Greens Creek Tailings Disposal

Final Environmental Impact Statement

Volume II

Response to DEIS Comments, October 2003

ATTACHMENT 3
MAP OF EAGLE NEST LOCATIONS

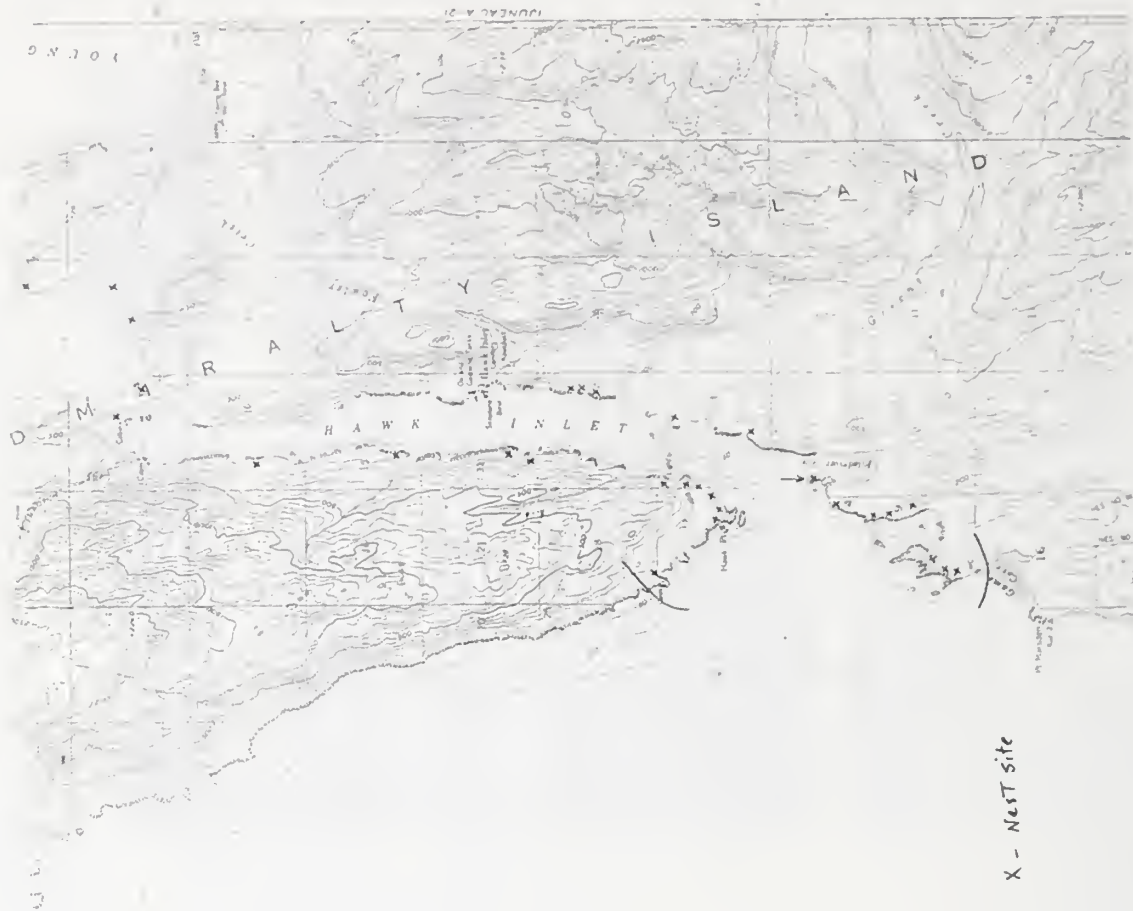
5.9 Figure 3-24 shows the locations of documented bald eagle nests based on 1970-1979 information. More recent information is available on bald eagle nest locations at Hawk Inlet. We recommend that the most current bald eagle nest location information, as shown in the enclosed topographic map (Attachment 3), be included in the Final EIS.

Figure 3-24 Bald Eagle Nest Tree Sites: Figure 3-24 shows the locations of documented bald eagle nests based on 1970-1979 information. More recent information is available on bald eagle nest locations at Hawk Inlet. We recommend that the most current bald eagle nest location information, as shown in the enclosed topographic map (Attachment 3), be included in the Final EIS.

Figure has been updated and renumbered to Figure 3-25.
